ADDENDUM NO. 2

January 11, 2024

Riviera Club Youth Pool and Equipment Building

This Addendum consists of Pages ADD 2-1 – ADD.2-3, Site Logistics Plan and Guideline Schedule, and Schmidt Associates Addendum No. 1 dated January 10, 2024, consisting of 2 pages and Specification Section, 061600 Sheathing, and Revised Addendum Drawings: CG101, CU101, CU501, CE101, CE501, AF1A1, AQ100, AQ200, AQ300, AQ500, and AQ703.

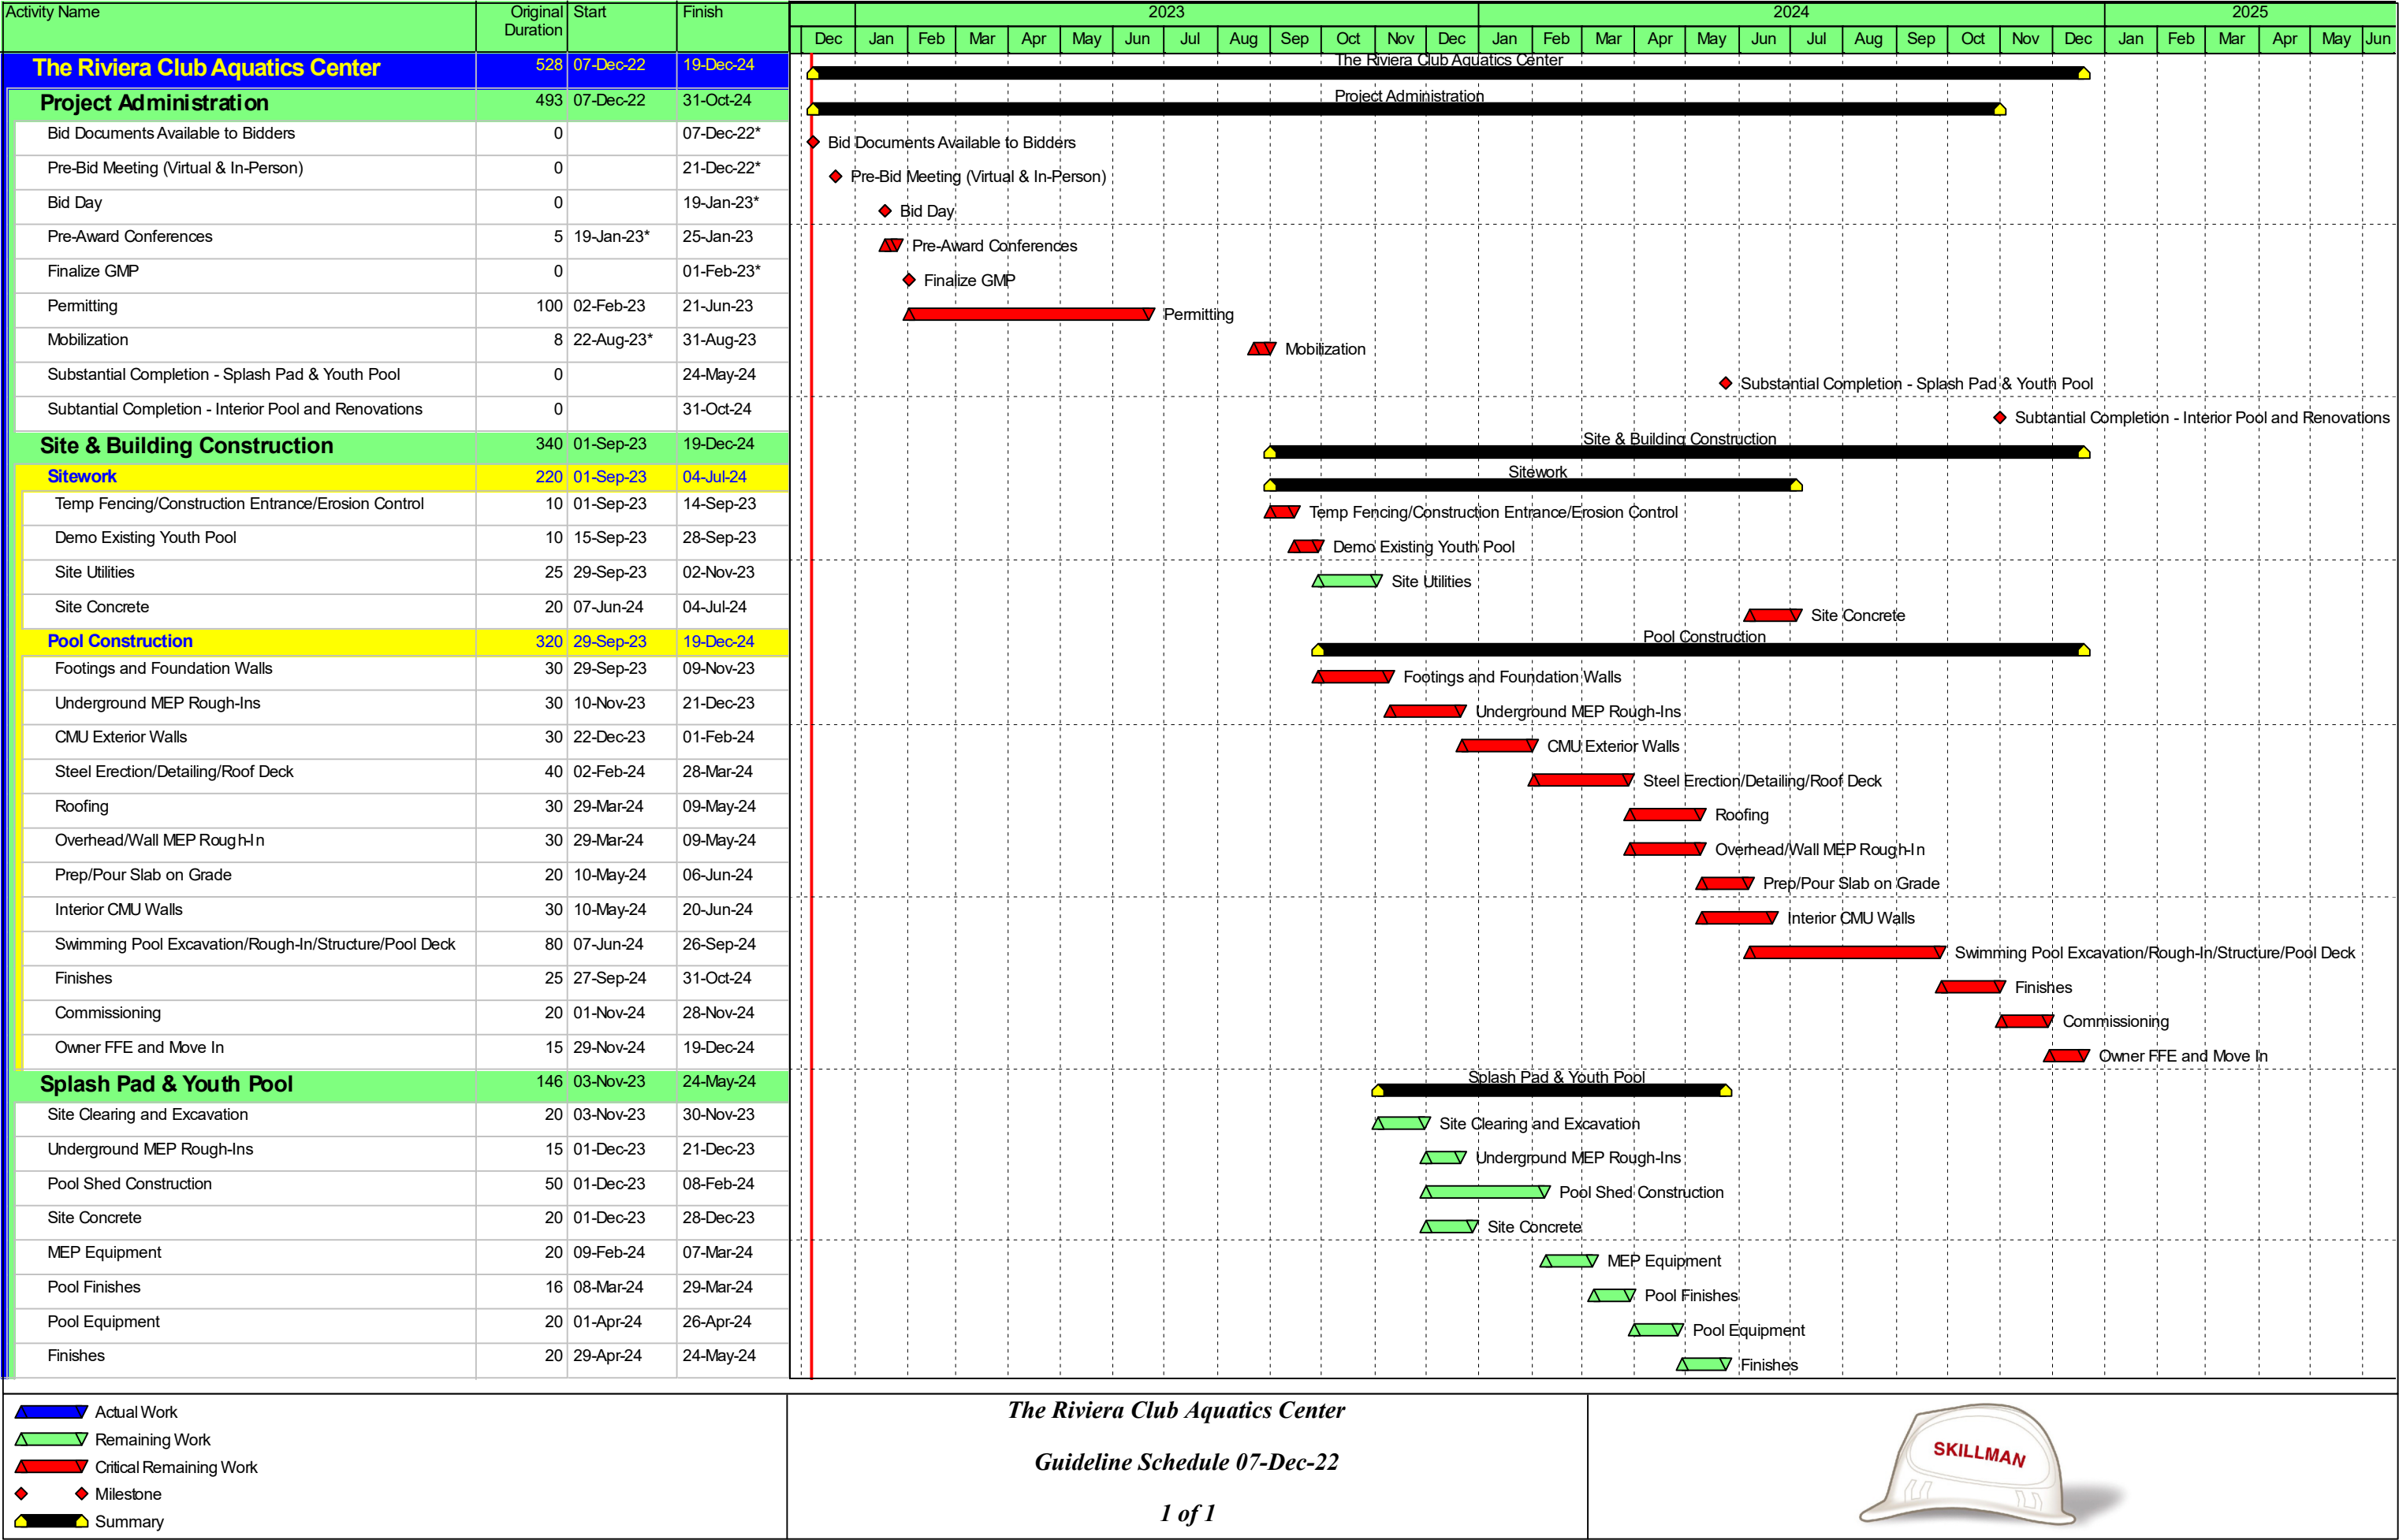
1. Replace the site logistics plan with the following. Note, Drawing Sheet CE101 describes Construction Entrance at existing lawn area, continue stone access as shown following:

YOUTH POOL DECK PLAN

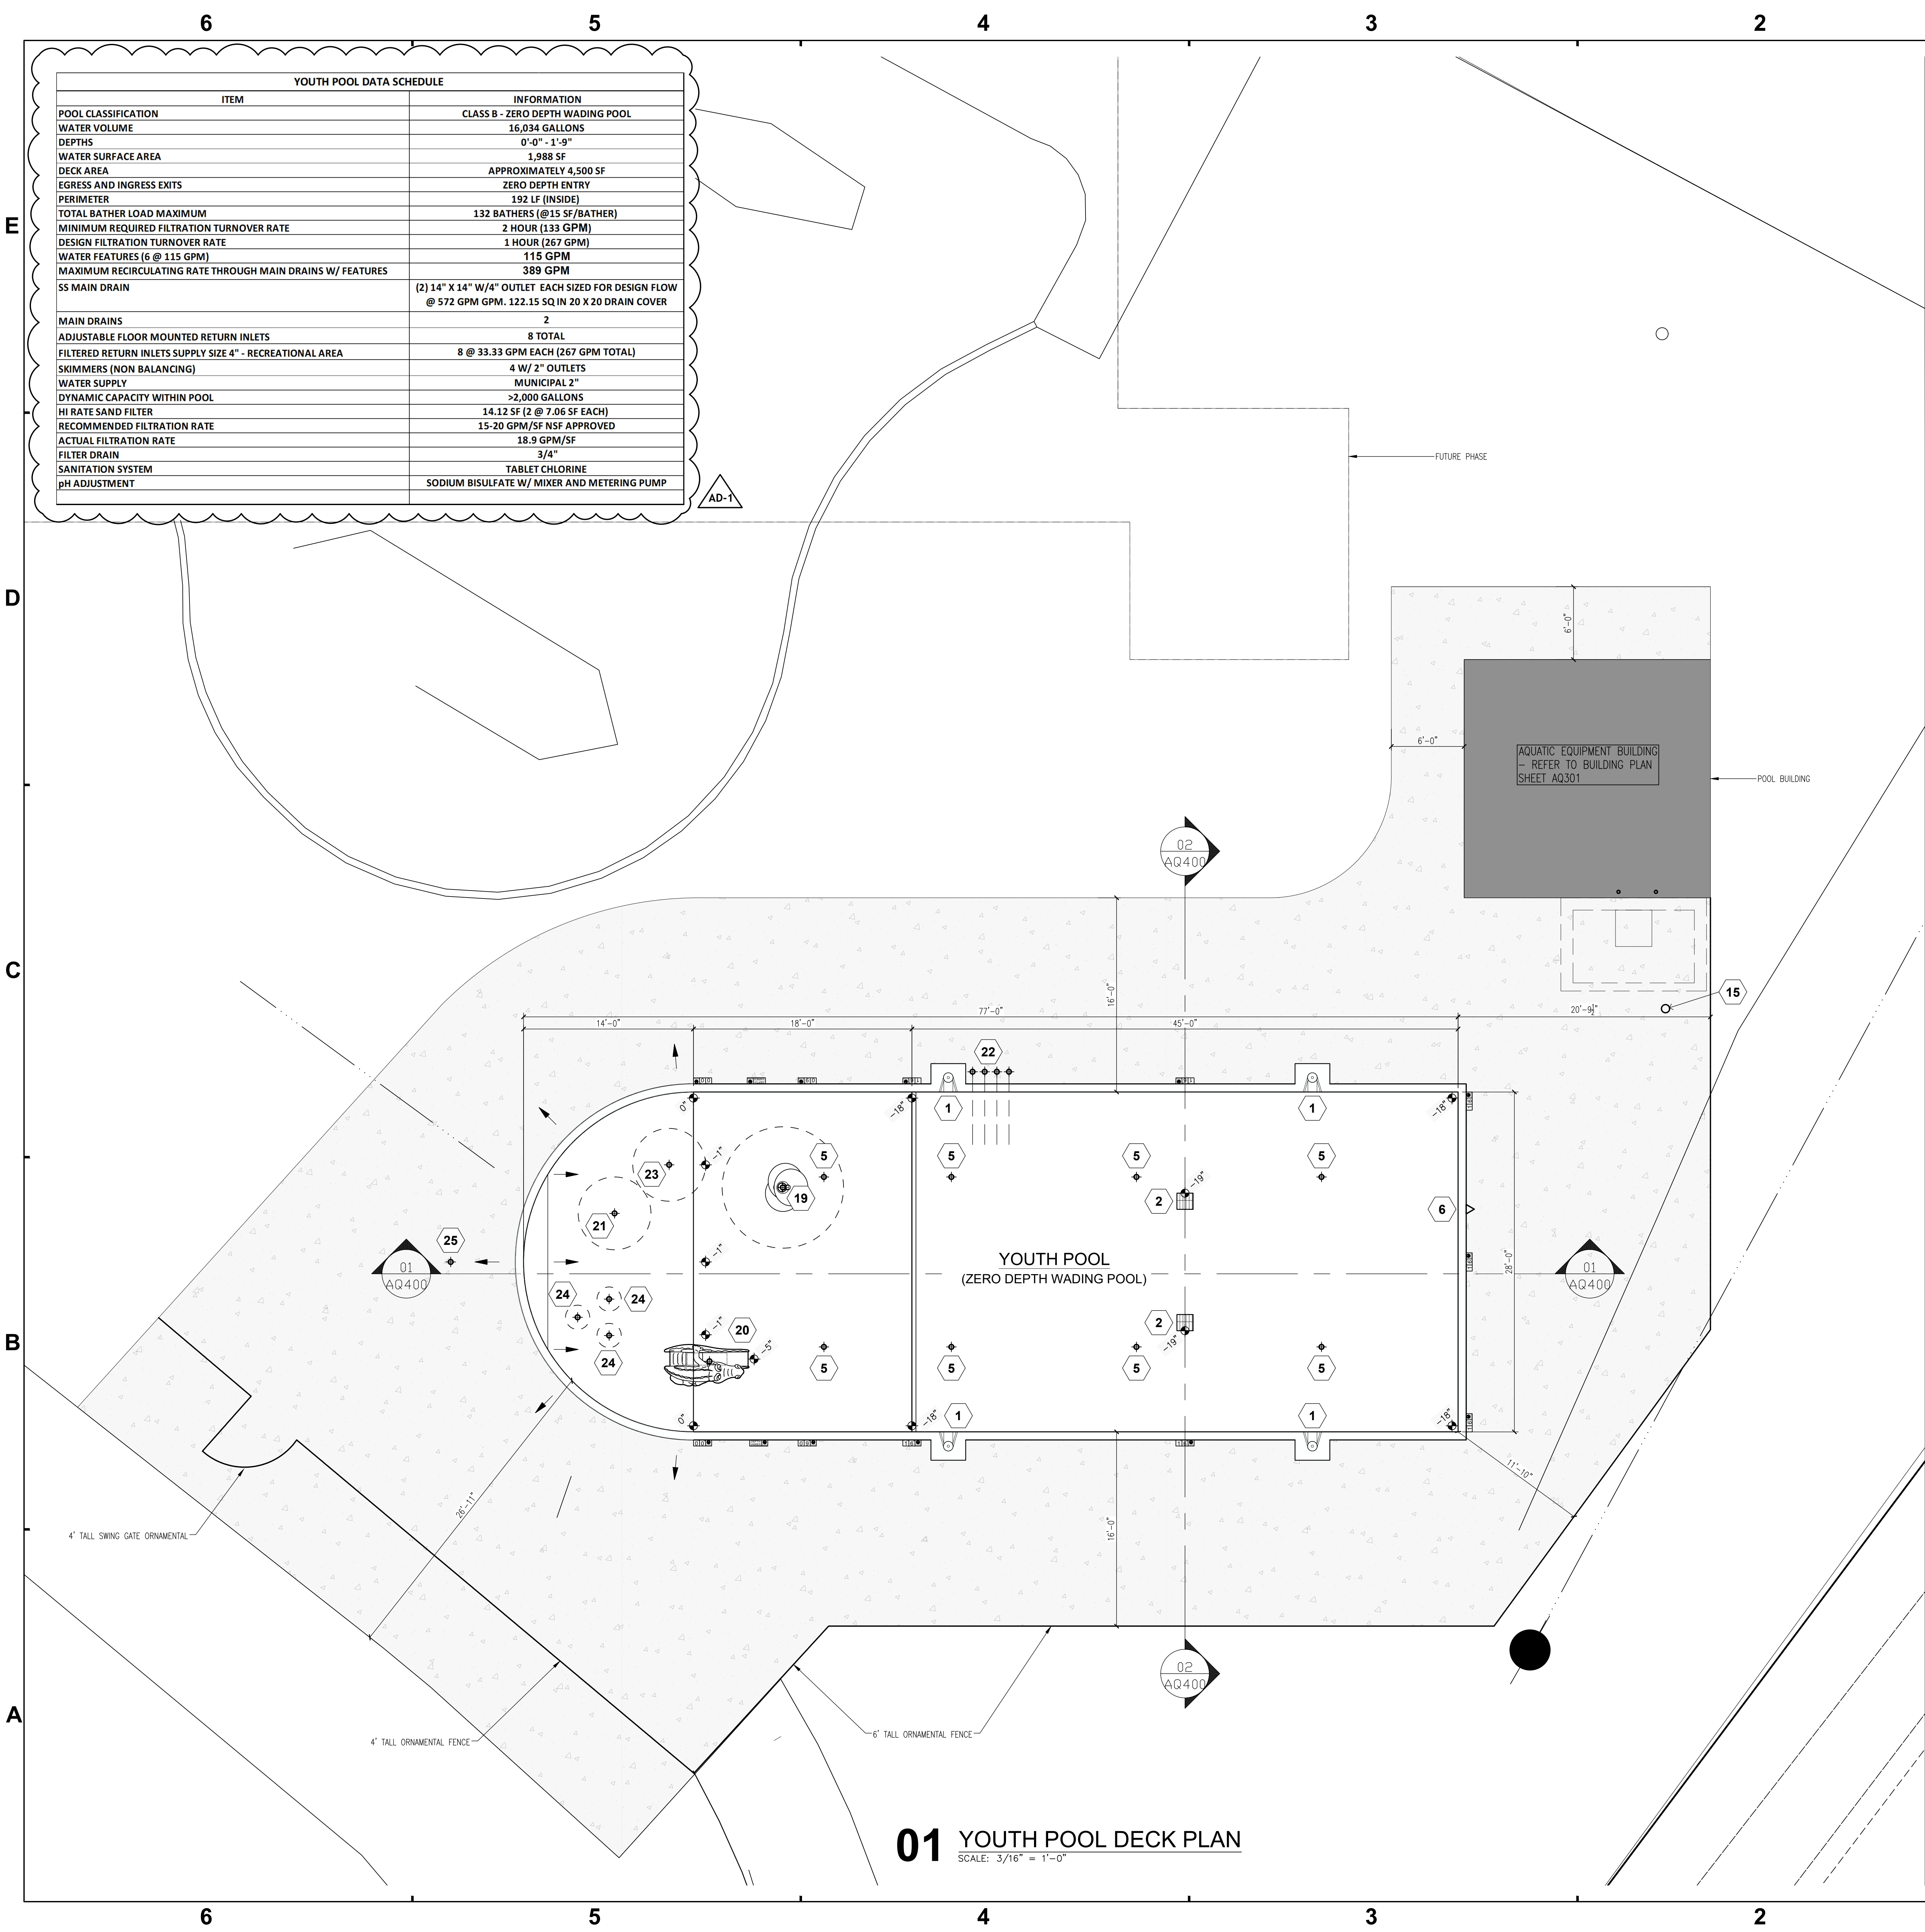
#	Revision	Date
AD-1	ADDENDUM #1: REVISED POOL DATA SCHEDULE.	01/10/24

POOL EQUIPMENT PLAN

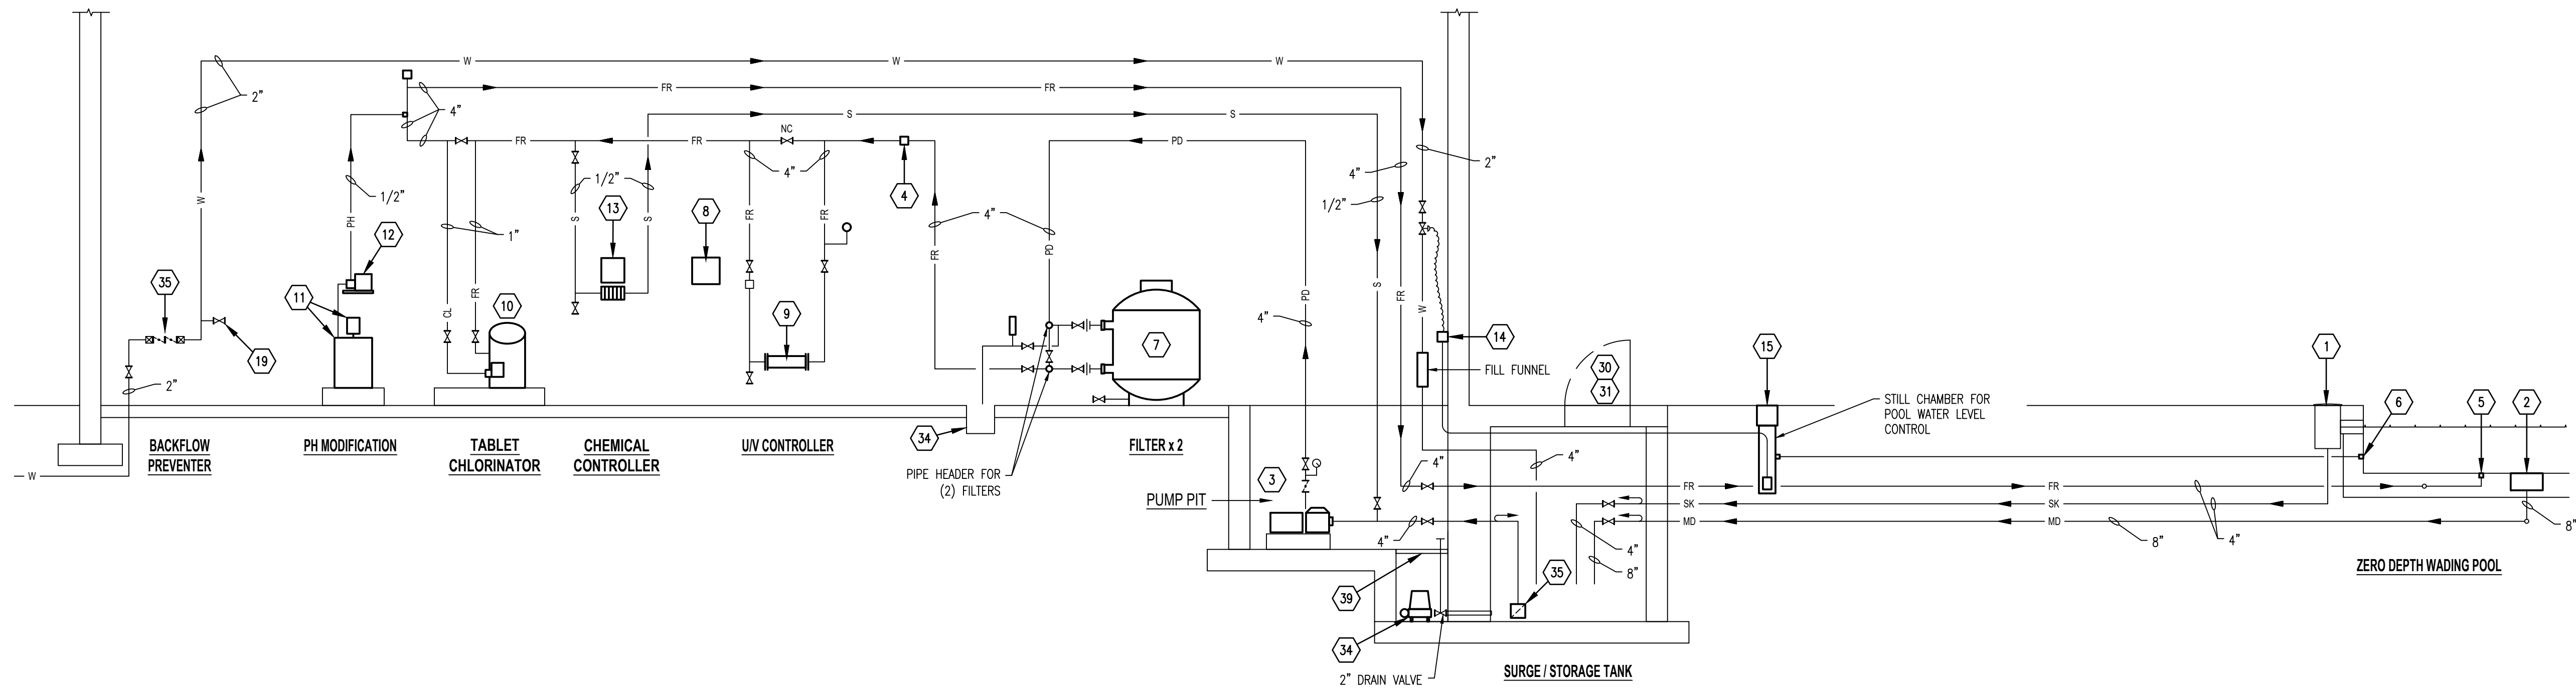
#	Revision	Date
AD-1	ADDENDUM #1: ADDED ITEM 26 TO EQUIPMENT SCHEDULE.	01/10/24
